# Final Commissioning Report For Eastmont High School

October 2015

## Commissioning Issues List

### Project: Eastmont High School

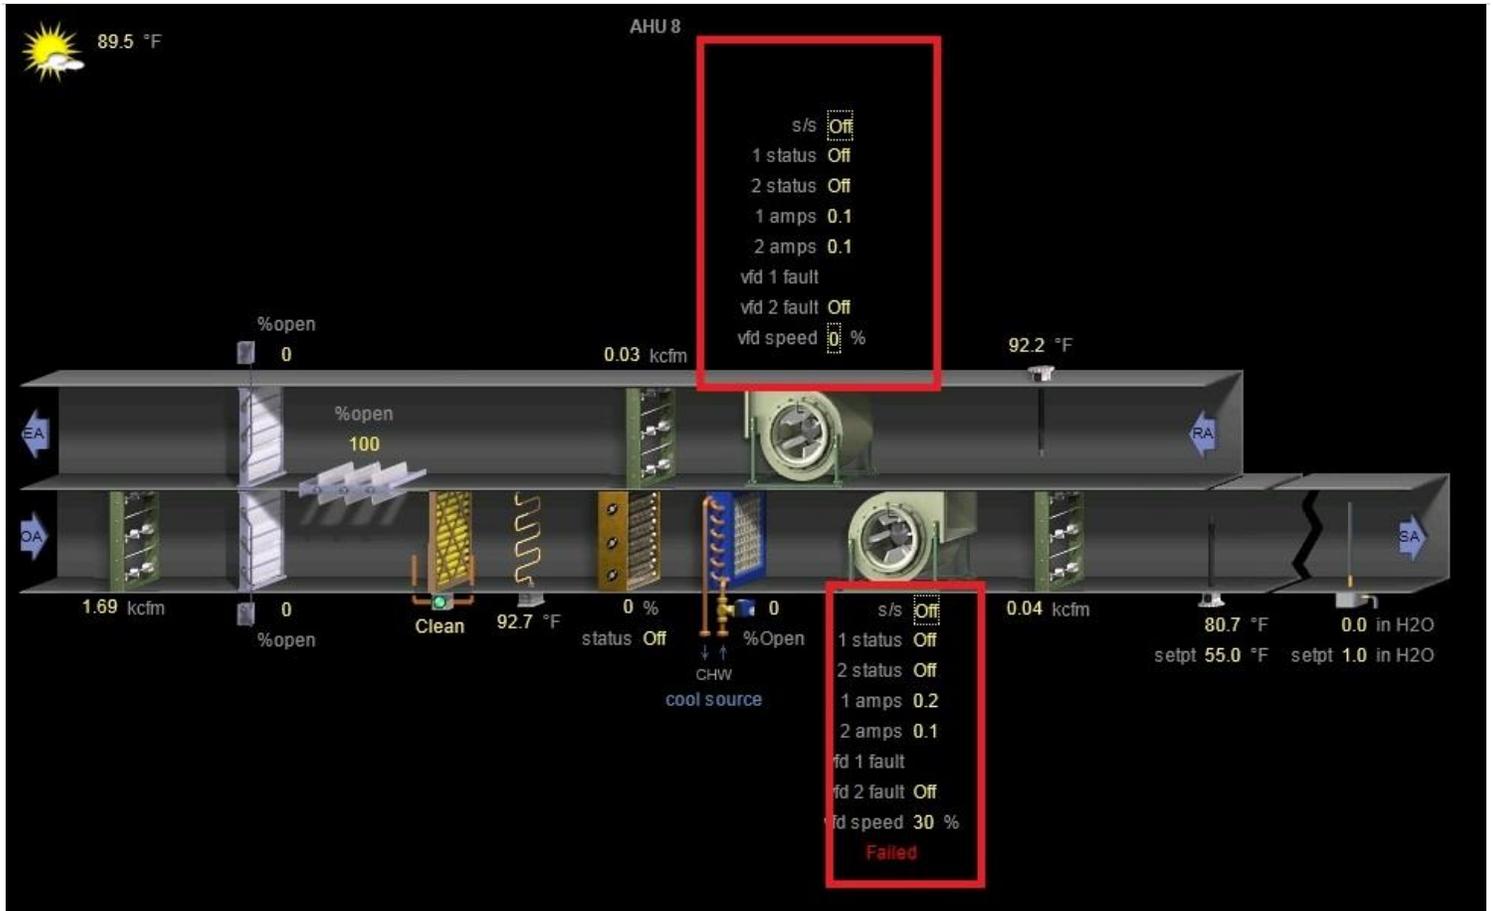
Issue ID #M-104—AHU-3 has failed and there is an unidentifiable alarm indicated towards a portion of the graphic that is not accessible. There is no way to scroll over in order to view it. Contractors should investigate and report back what findings there are prior to additional onsite Cx testing. Graphic should be so that it can be seen in its entirety.

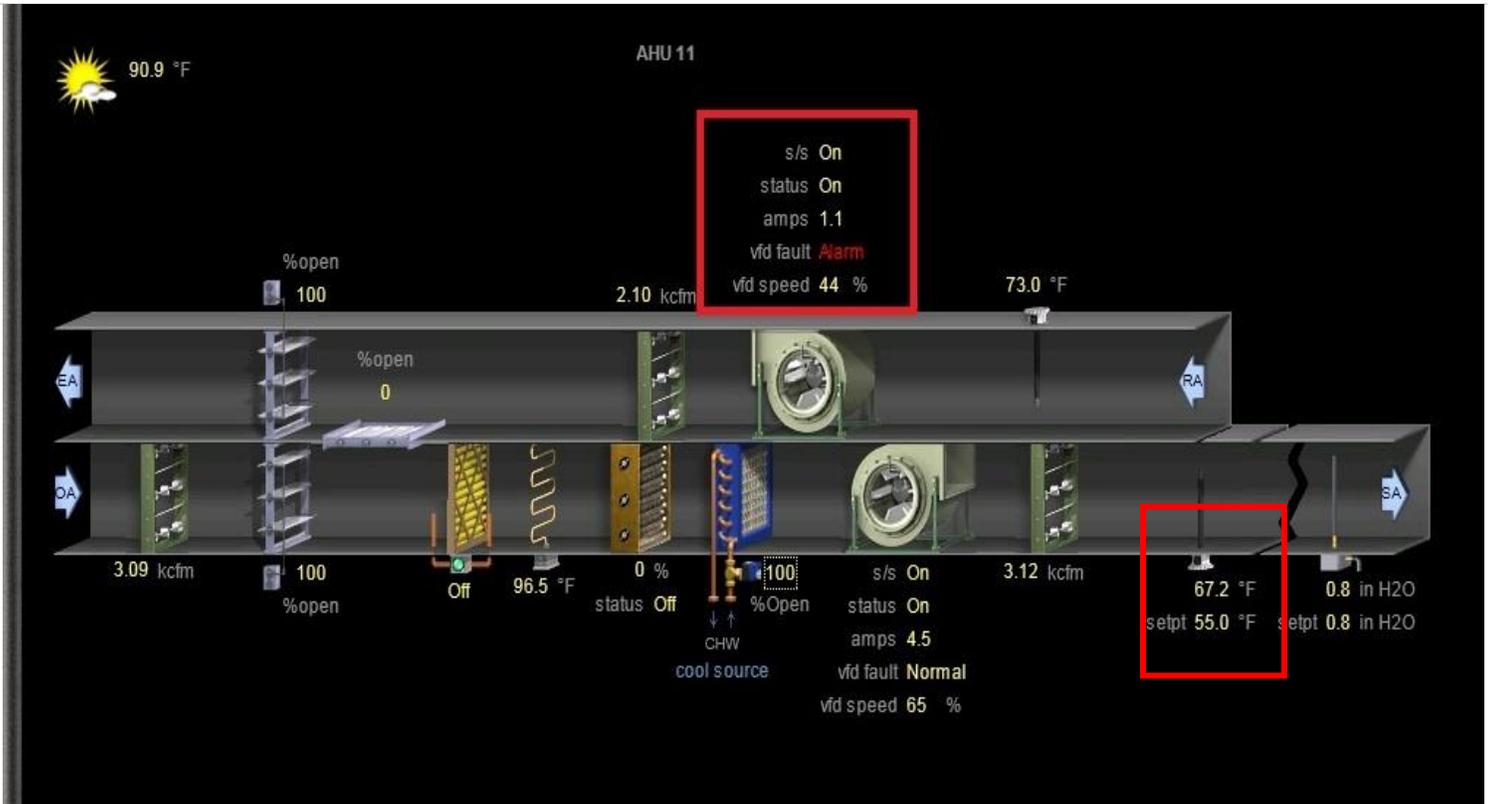
Issue ID #M-105—AHU-6 Return Fan has failed. Contractors should investigate and report back what findings there are prior to additional onsite Cx testing. Notice discharge air temperature with CW control valve wide open which is related to the concerns over the chilled water loop temperature.

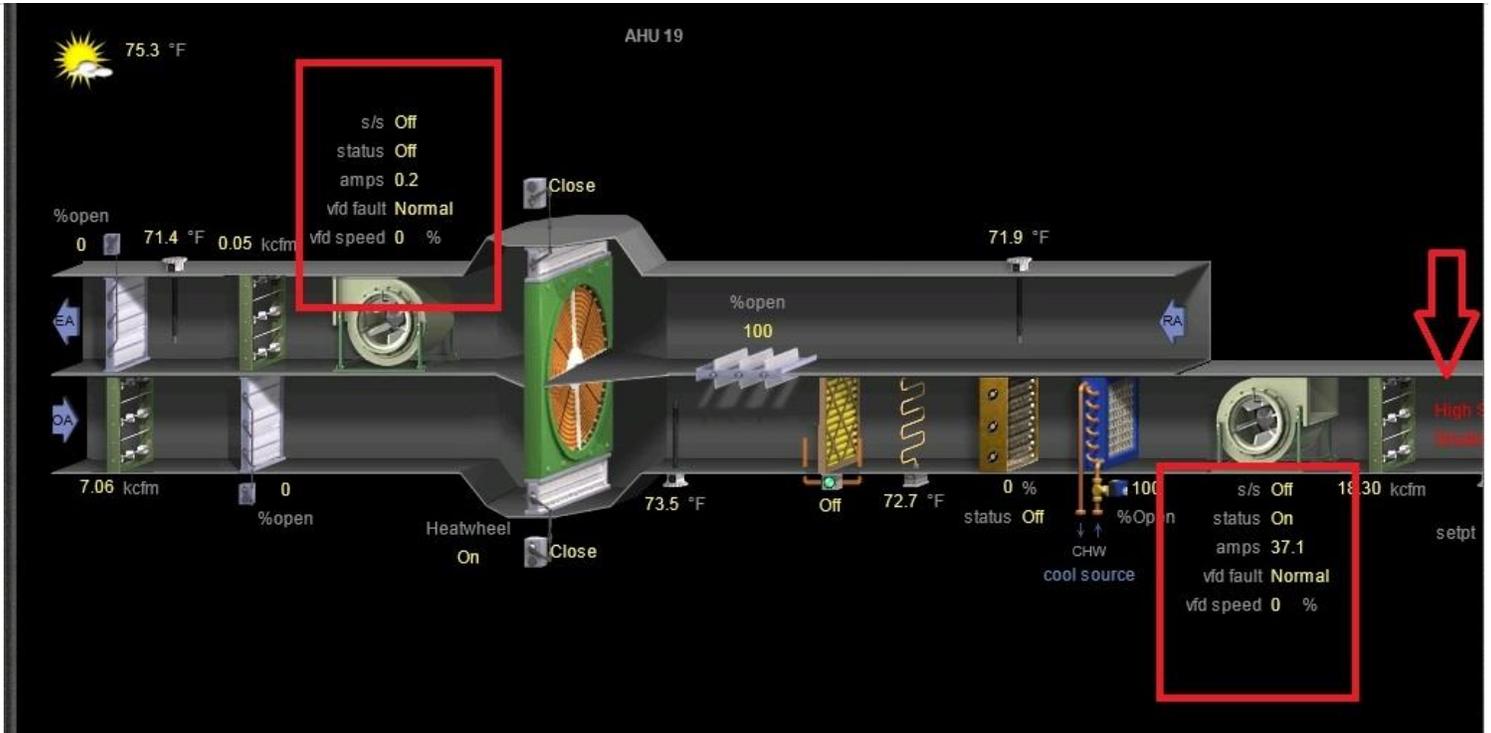
Issue ID #M-106—AHU-8 has failed and been overridden off.
